Process Presentation
Lighting
Iron - Furniture - Sculpture
Legrand – Lumicor – LED

CONSULTING
DESIGN & MANUFACTURING
ADG Lighting
Architectural Detail Group, Inc

PROPOSED
EXTERIOR ELEVATIONS

PROPOSED FLOOR PLAN

1 SOUTH ELEVATION
1/4" = 1'-0"

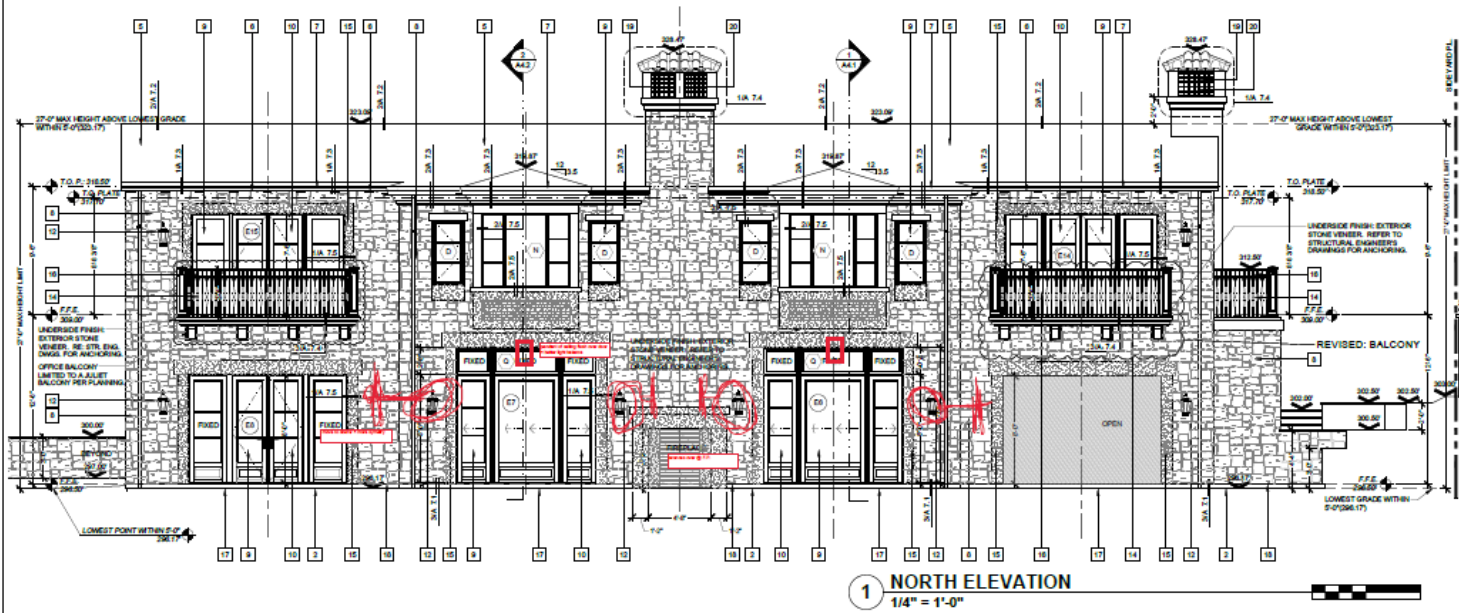
this screen describes our notes as to the proper placement of exterior lighting against the original plan

1 NORTH ELEVATION
1/4" = 1'-0"

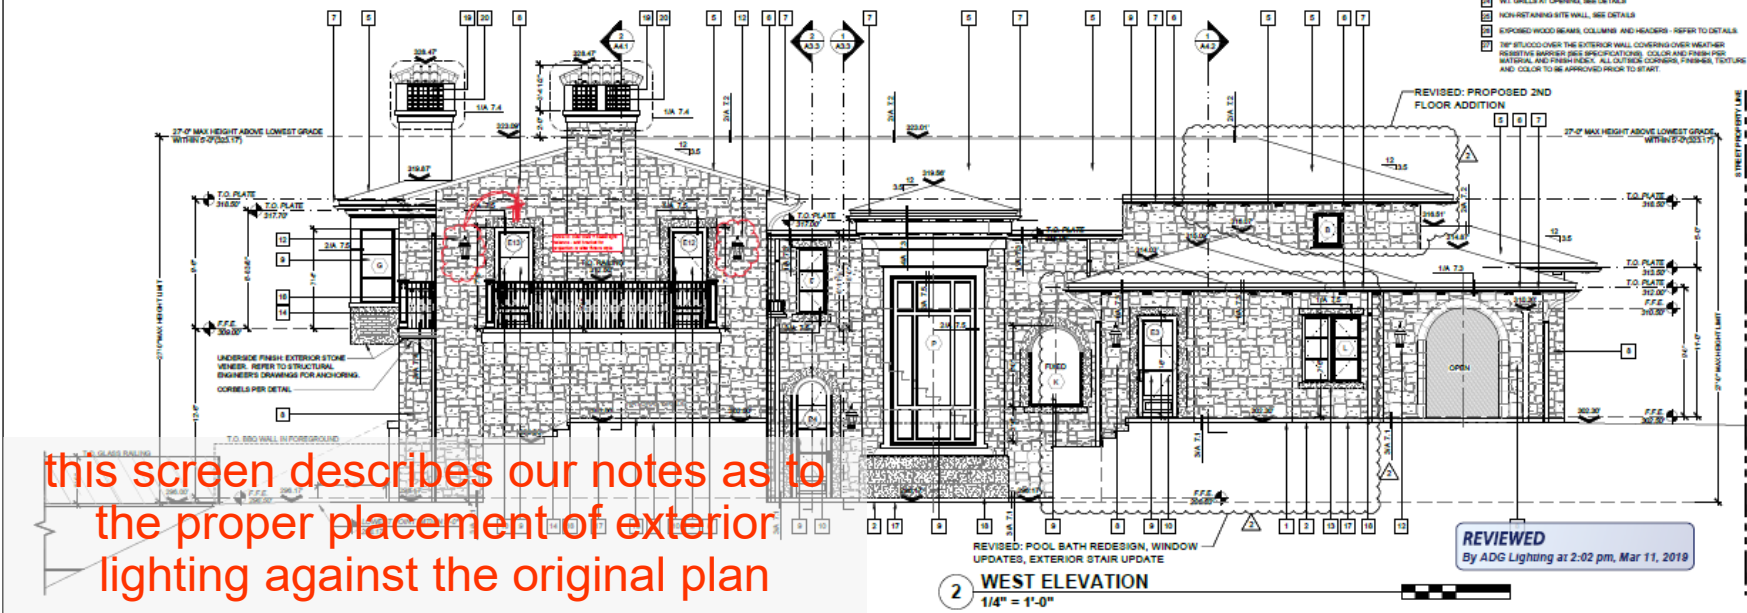
this screen describes our notes as to the proper placement of exterior lighting against the original plan

1 NORTH COURTYARD ELEVATION + SECTION
1/4" = 1'-0"

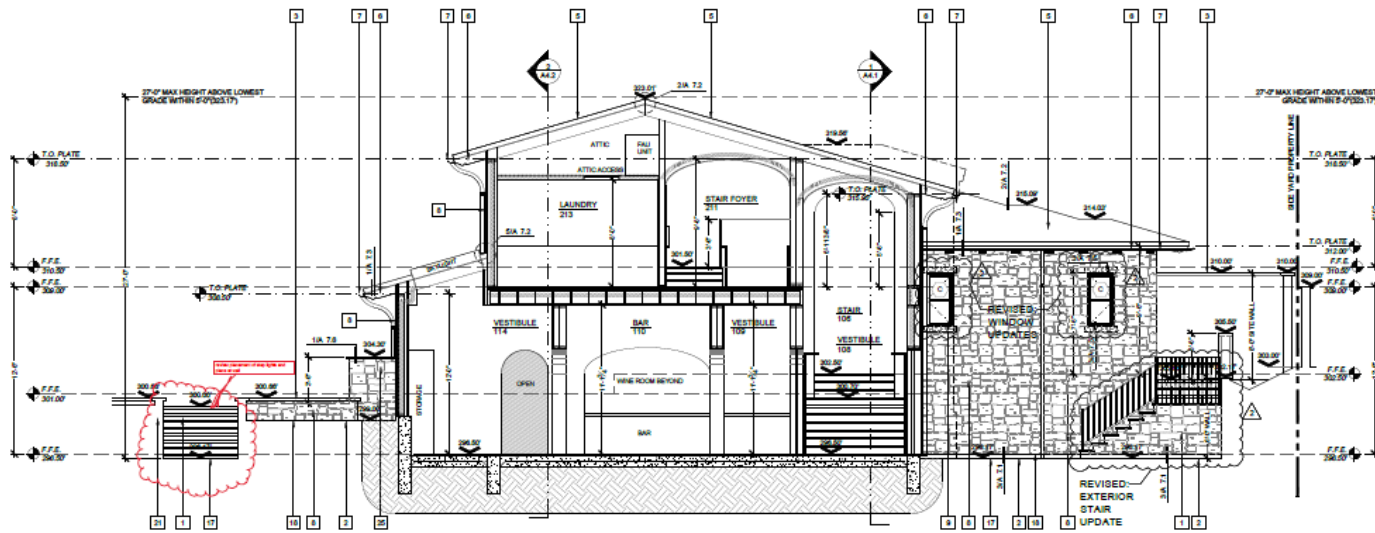
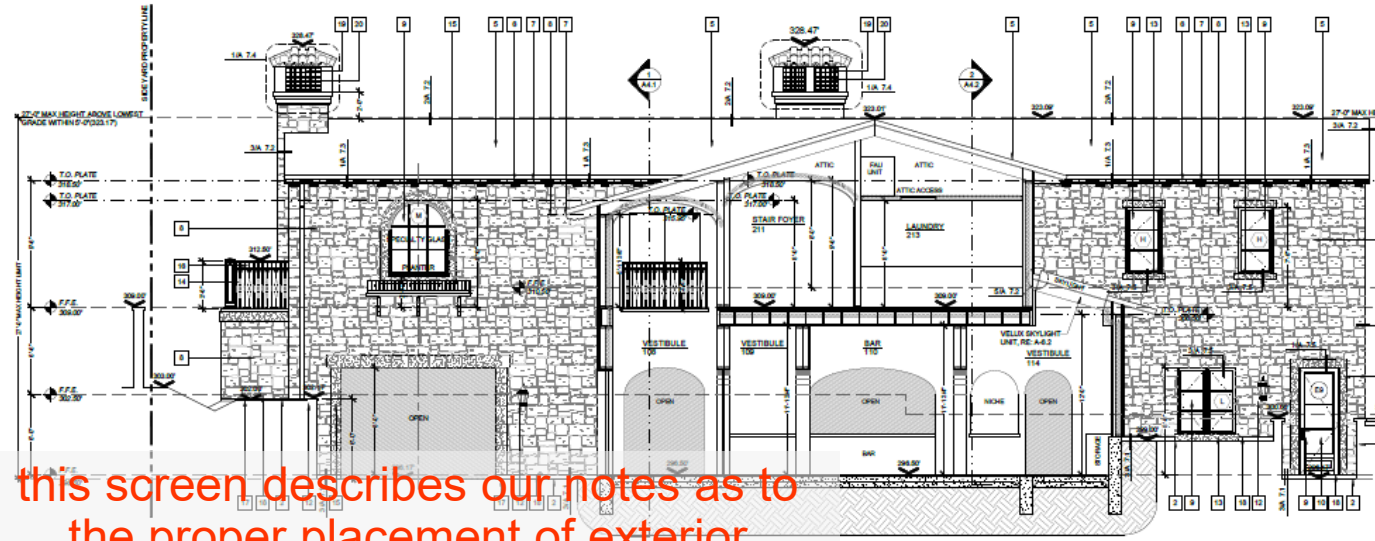
this screen describes our notes as to the proper placement of exterior lighting against the original plan

DRAWING NO. **A2.1**

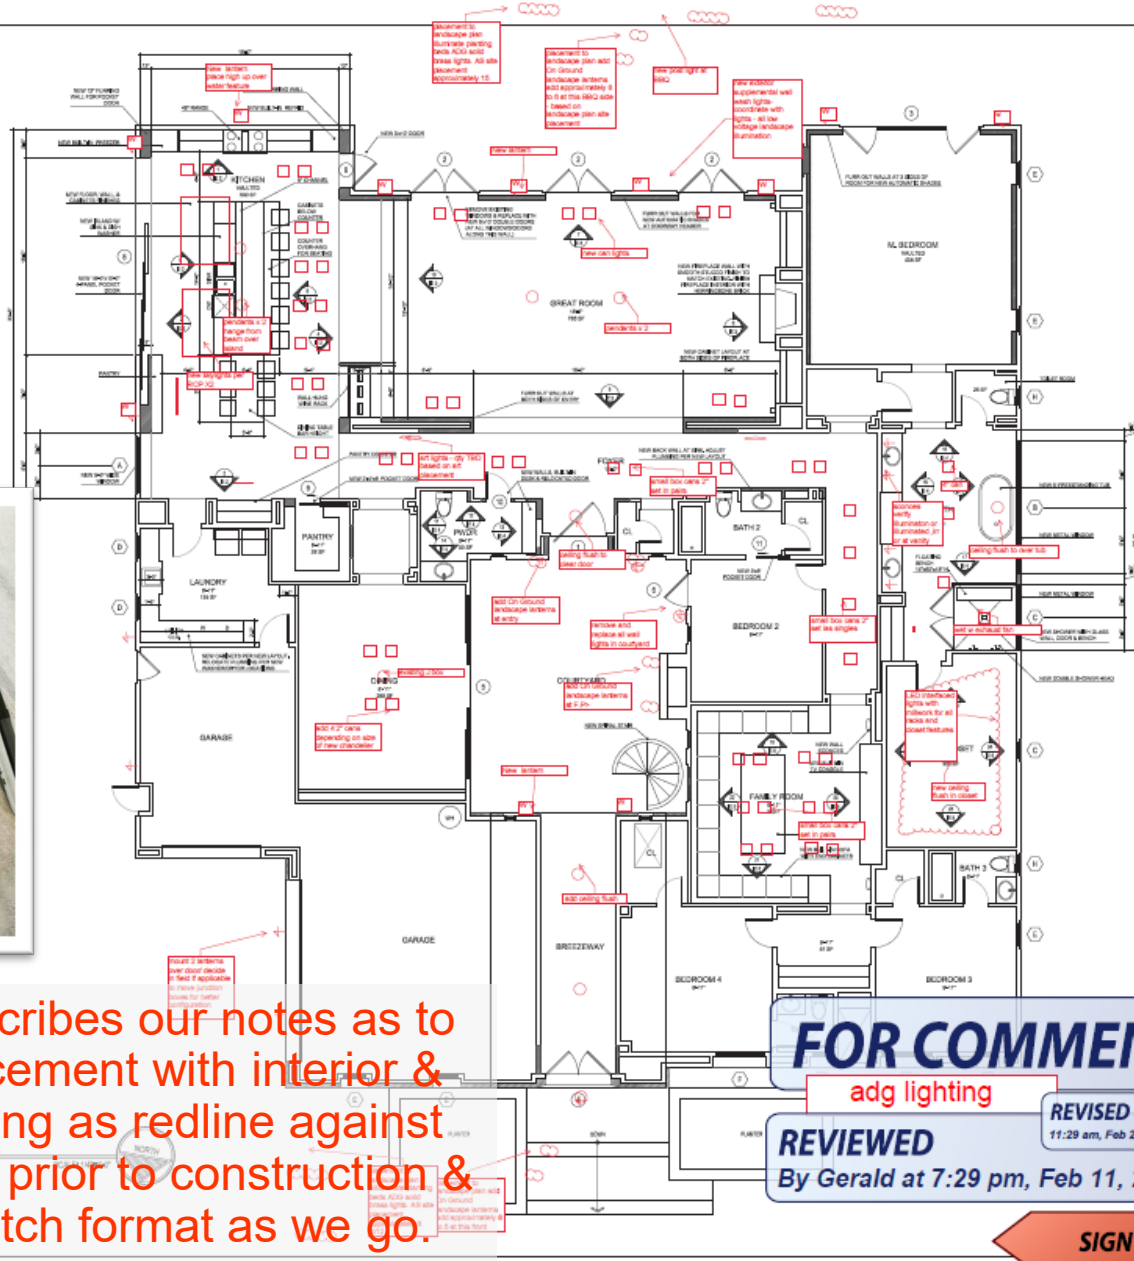
IT'S BEST
This is a preliminary plan based on field site visit.

Specific can lights and locations of fixtures must be approved and marked as job.

Site visits needed to determine additional locations and replacement of can lights and surface lights.

Note: All cans to be either 500w or 100w and gully placement thru floor lighting.

All new walling to be L-shaped surfaces and ceiling (LSC).

ACG fixtures are still needed lighting is preliminary to approved equipment and fixture lighting is needed.

this screen describes our notes as to the proper placement with interior & perimeter lighting as redline against the original plan prior to construction & thinking in sketch format as we go.

1st Floor - Image 1

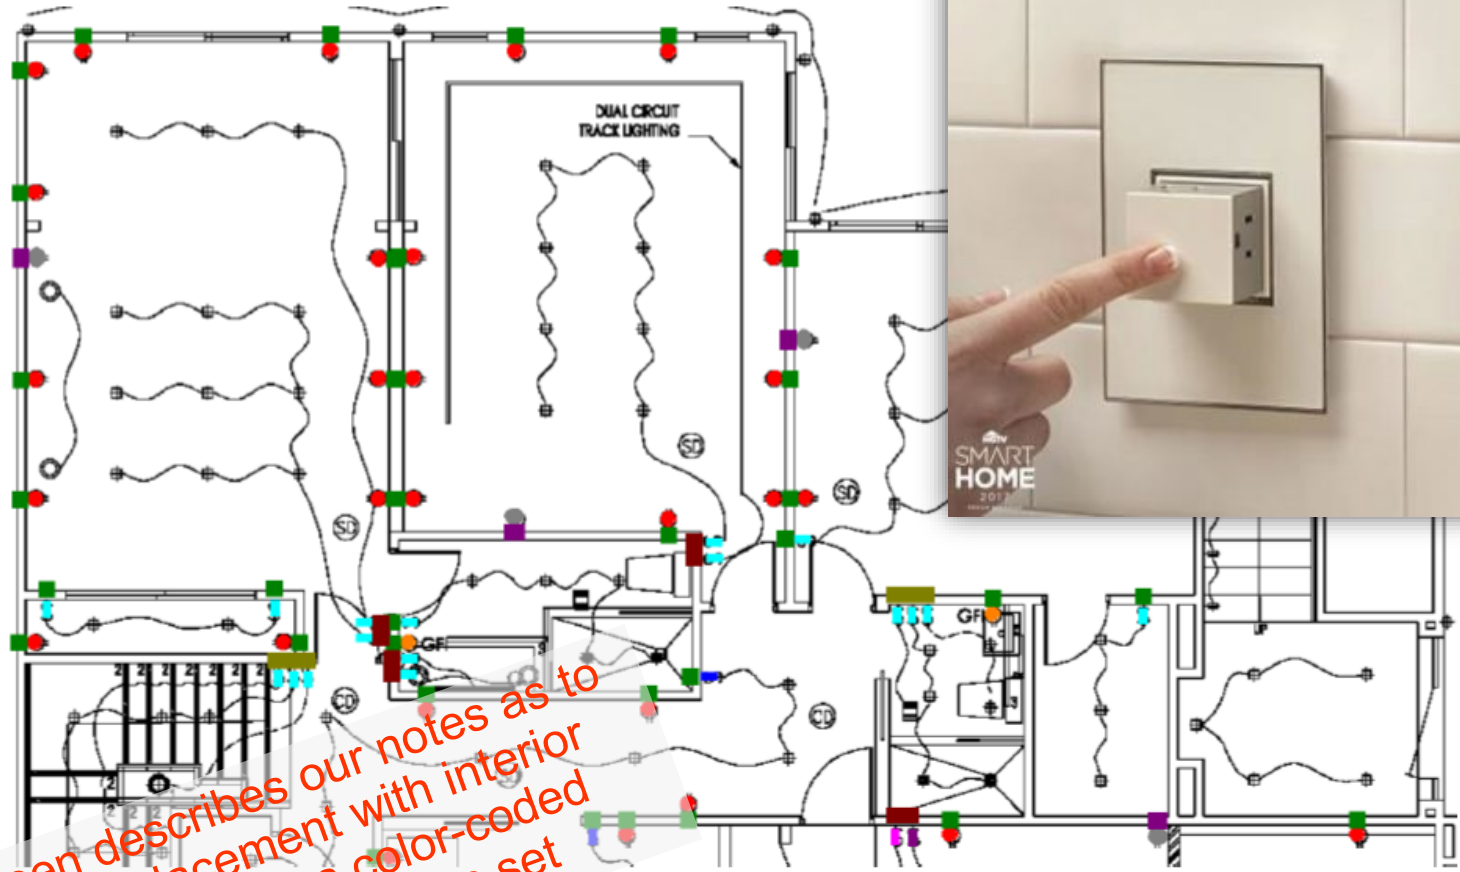
this screen describes our notes as to the proper placement with interior Legrand controls as color-coded against the original plan set

1st Floor - Image 2

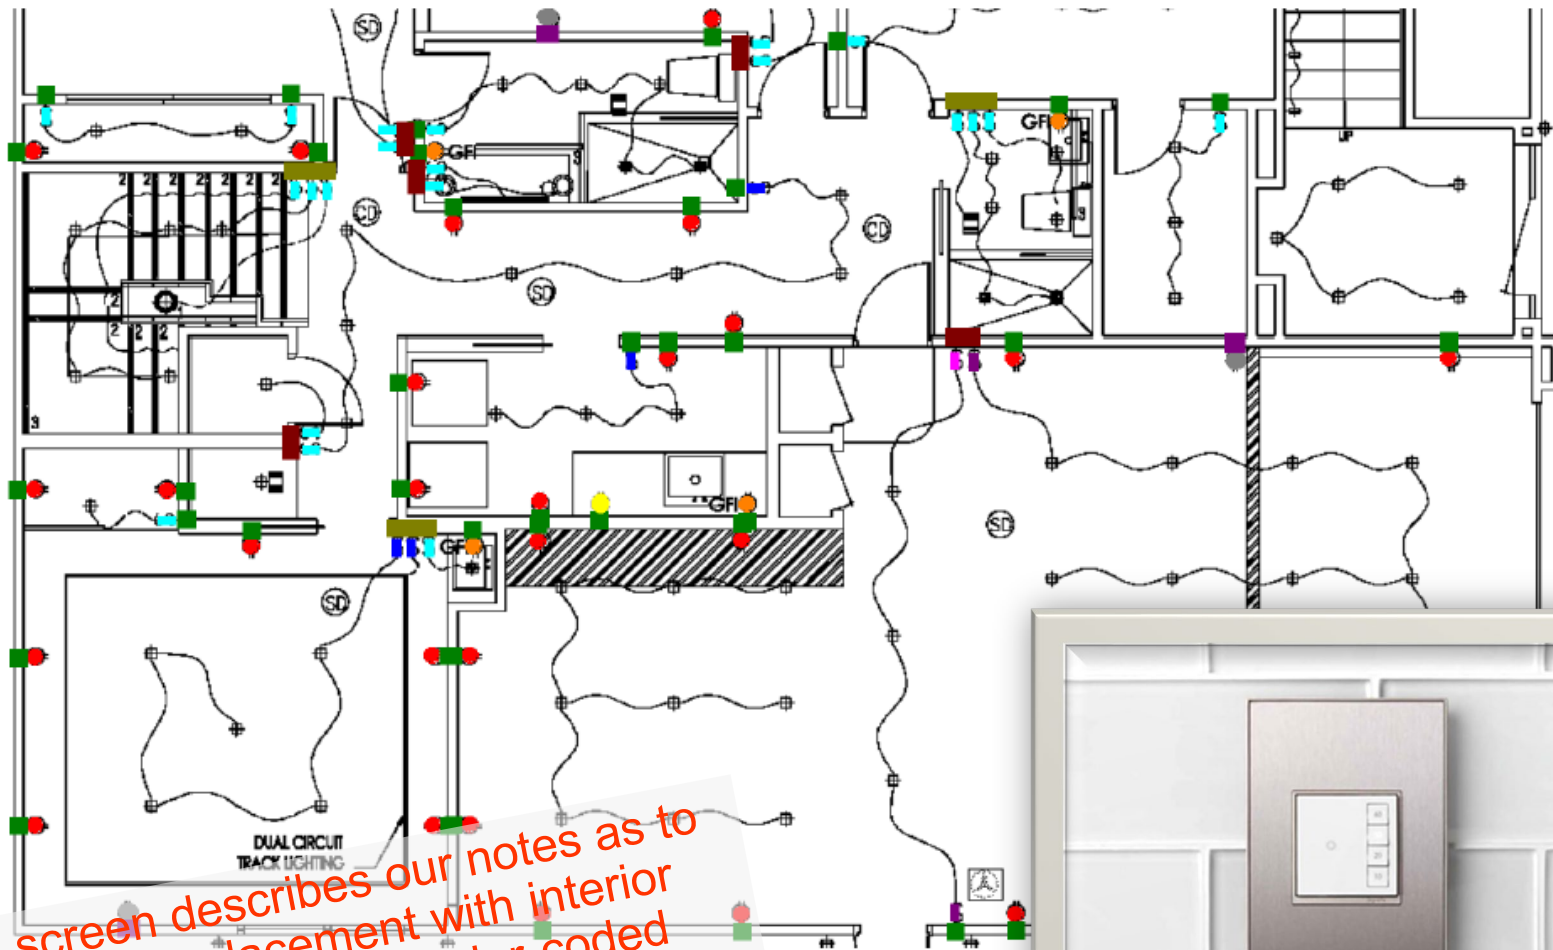
this screen describes our notes as to the proper placement with interior Legrand controls as color-coded against the original plan set

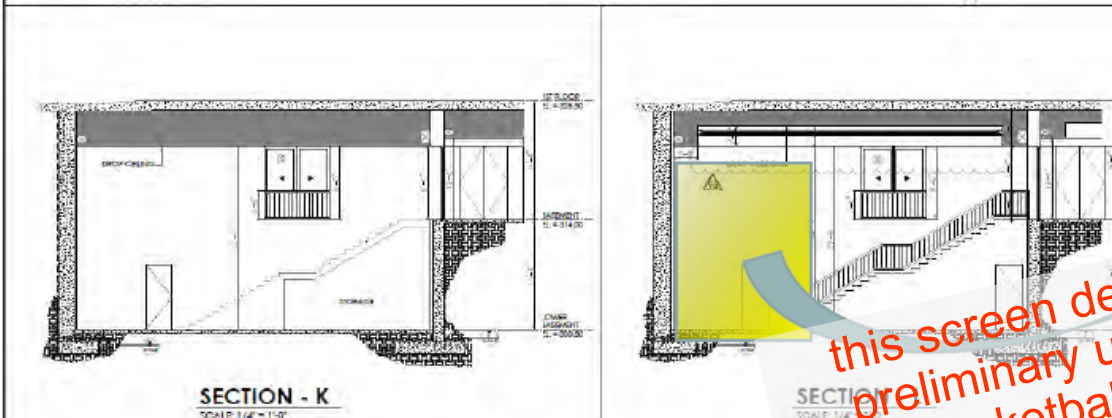
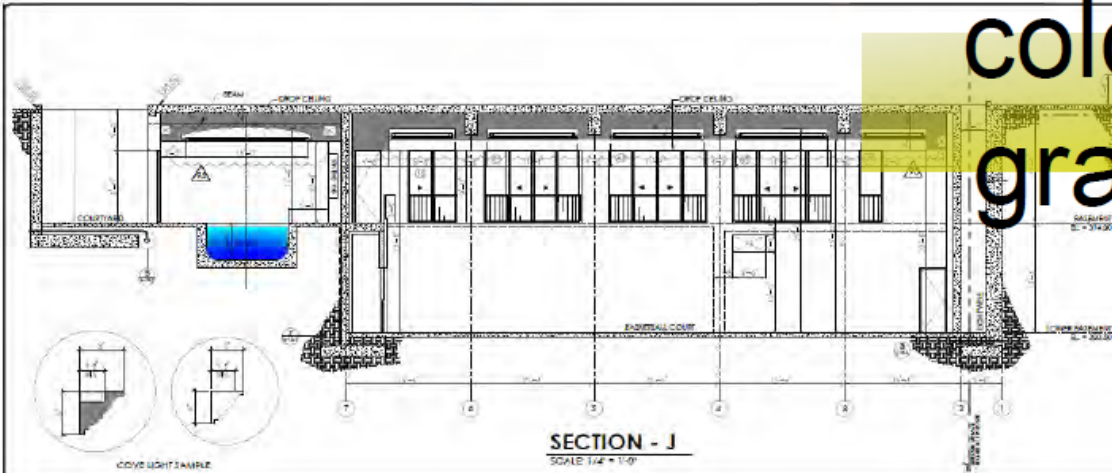
this screen describes our notes as to the preliminary use location to backlight the basketball court light wells. This is preliminary to engineered solutions

Simple tone on colored lumicor graphic for this wall
